**Town of Thompson's Station
Design Review Commission
Meeting Agenda
June 2, 2022**

1. Design Review for a 7,216 square foot mixed use commercial building at 2197 Portsmouth Drive in the Tollgate Village Subdivision.

Design Review for a 7,216 square foot commercial building located at 2197 Portsmouth Drive within the Tollgate Village neighborhood.

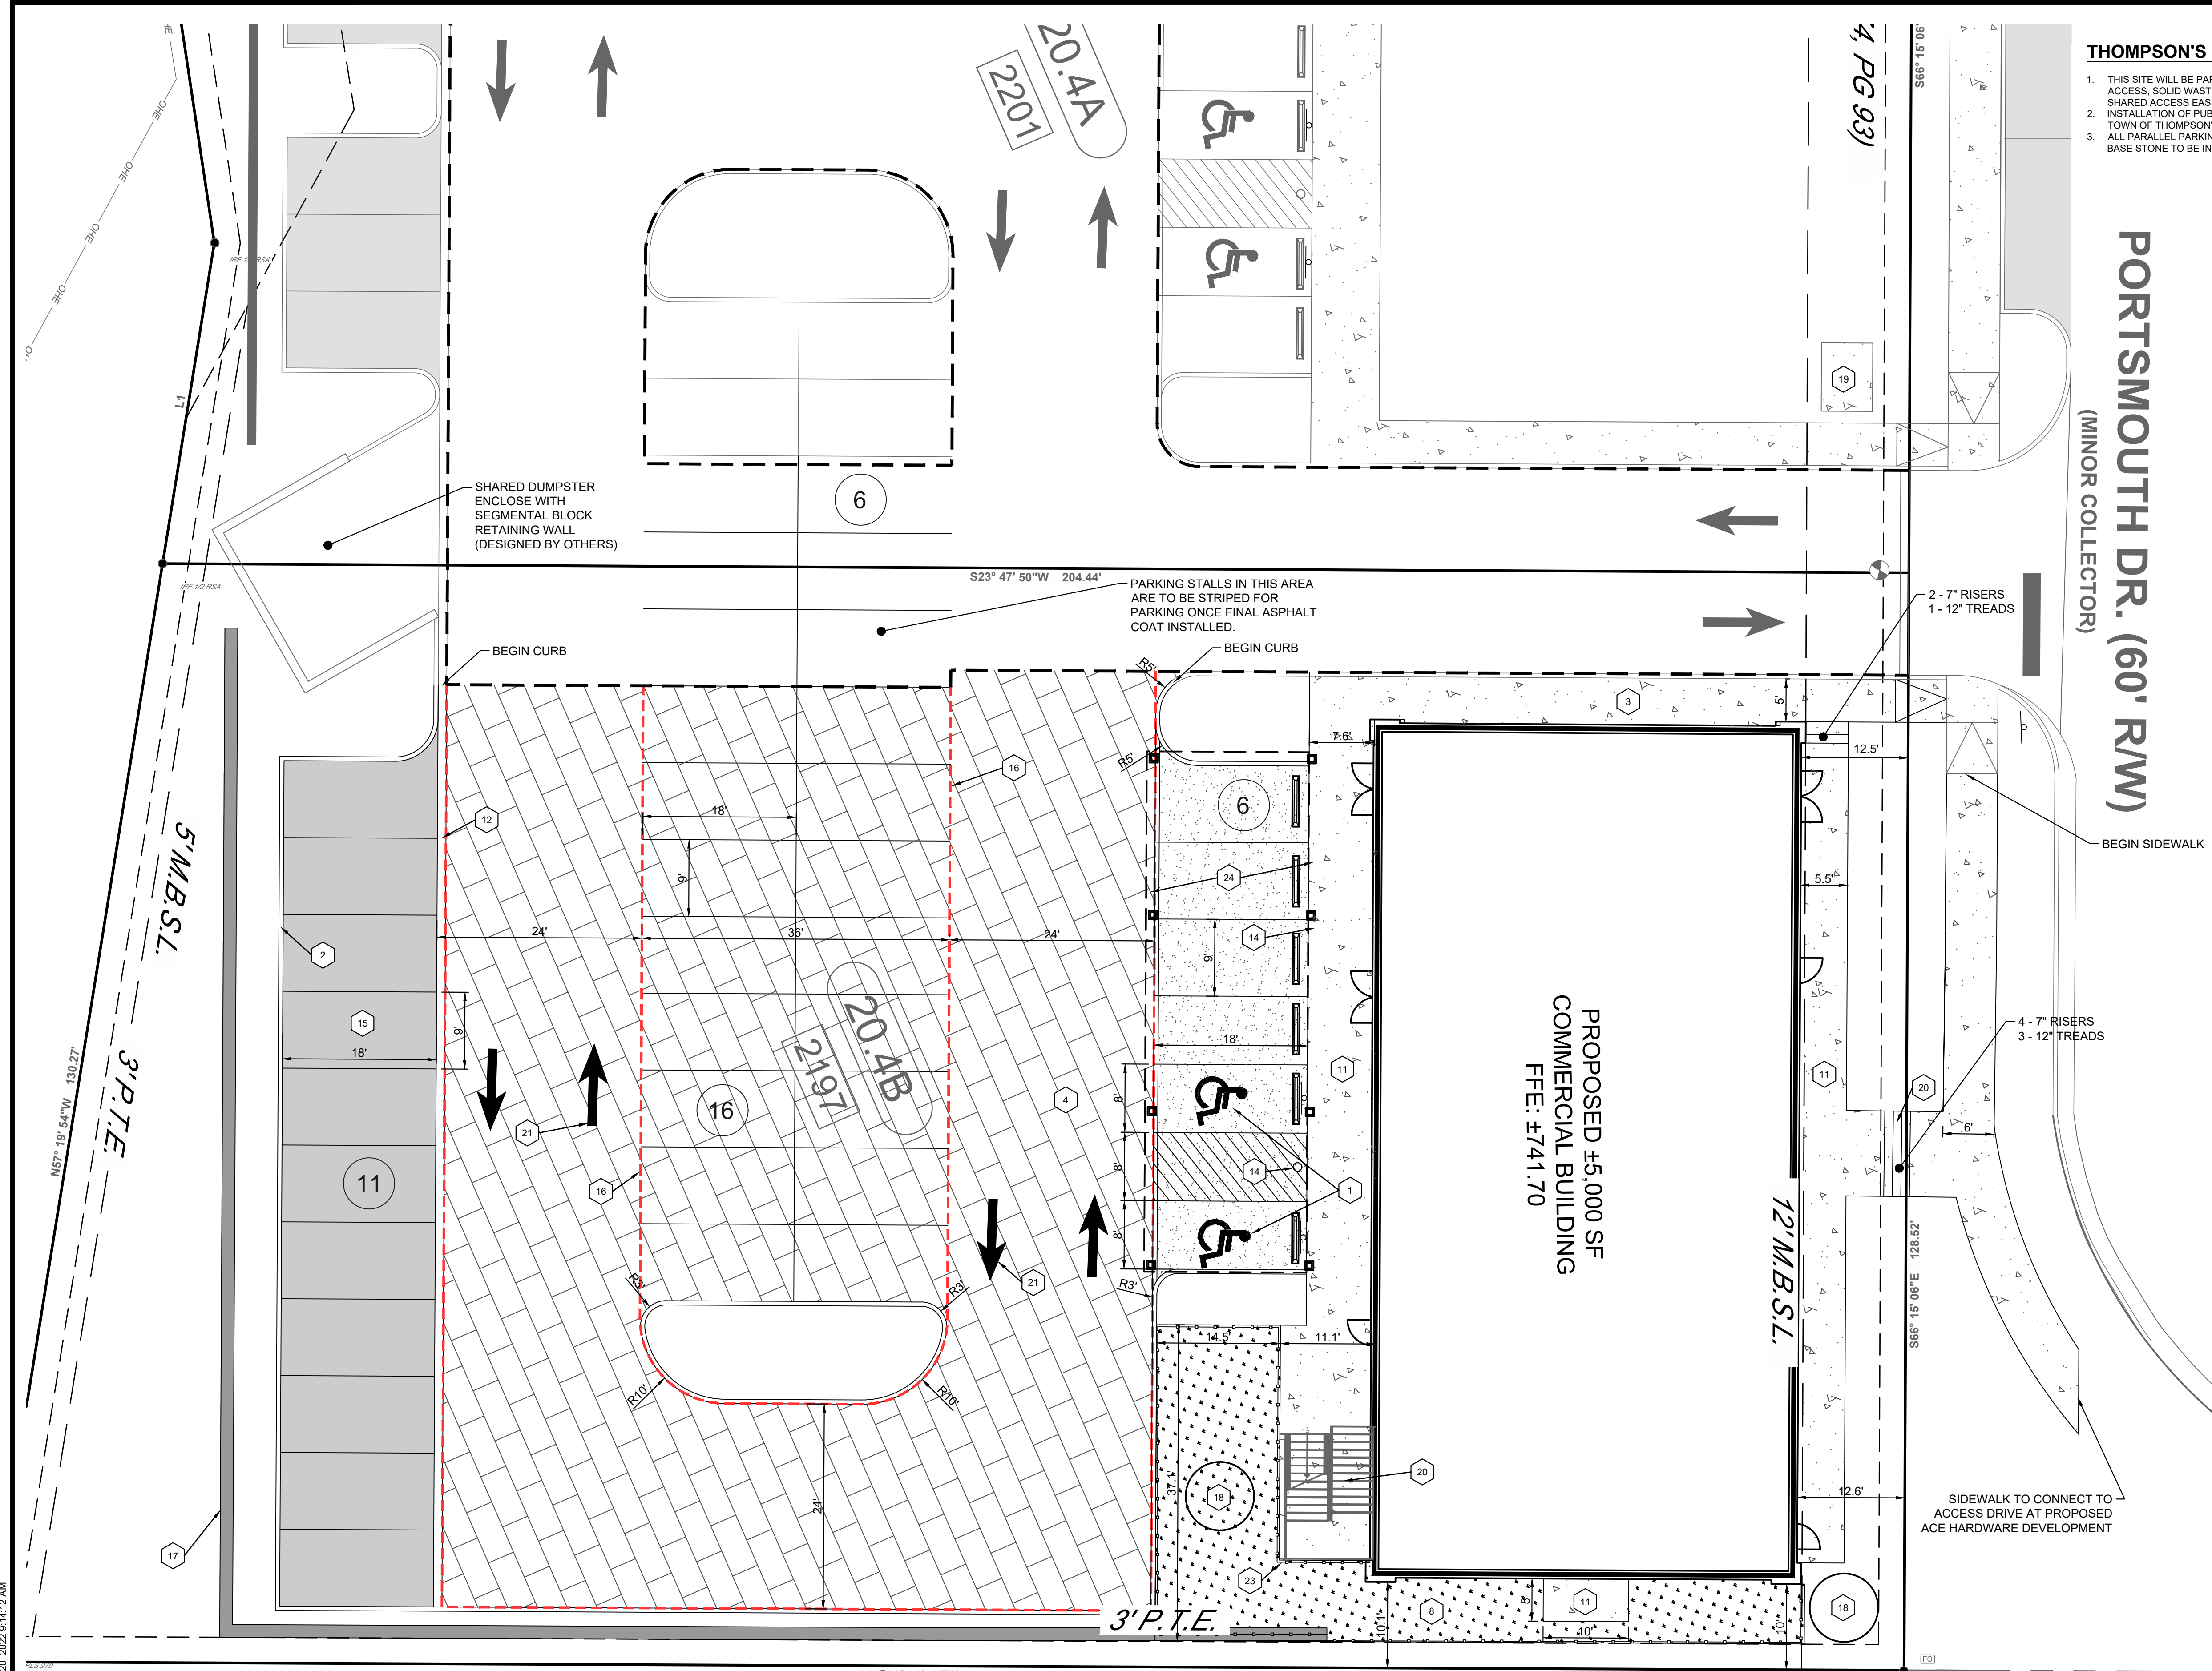
The building's exterior includes brick veneer, pre-finished fiber cement board, and batten siding and lap siding as the primary materials on the North/Portsmouth Drive elevation. The South elevation exterior, which opens to the parking area, includes board and batten siding as the primary material. The East and West elevations consist entirely of brick veneer. The building materials generally comply with the Design Guidelines. The overall building design is mostly consistent with the Design Guidelines. Some minor adjustments along the Portsmouth Drive/North elevation will help this development fit within the emerging development pattern within the commercial section of Tollgate Village. The East, West, and South elevation require no adjustments, per Staff's review. The Portsmouth Drive/North elevation does provide some articulation and detailing for a storefront; however, Staff recommends that the primary entrance ways be better defined in order to provide more definition along this street-facing elevation; that the canopy be revised to be a continuous design feature along this elevation; and that the glazing on the ground floor be recalculated/revised along this elevation per the DRC's previous metric of using the canopy/pedestrian height as the standard for this measurement. Overall, the presented architectural design achieves the Town-wide Design Principles of Character, Compatibility, and Views, with minor adjustments, included as conditions to the Staff recommendation of approval.

Based on the project's general consistency with the Town's Design Guidelines, Staff recommends approval of the building architectural elevations, with the following conditions:

1. The applicant shall provide more definition to the main entrance way(s) along the Portsmouth Drive elevation to provide a greater sense of focus from the street.
2. The applicant shall provide a continuous canopy across the Portsmouth Drive elevation.
3. The applicant shall update the glazing calculation provided on the North/Portsmouth Drive elevation. If needed, the applicant shall provide sufficient glazing to satisfy the required glazing minimum on the Ground Floor.
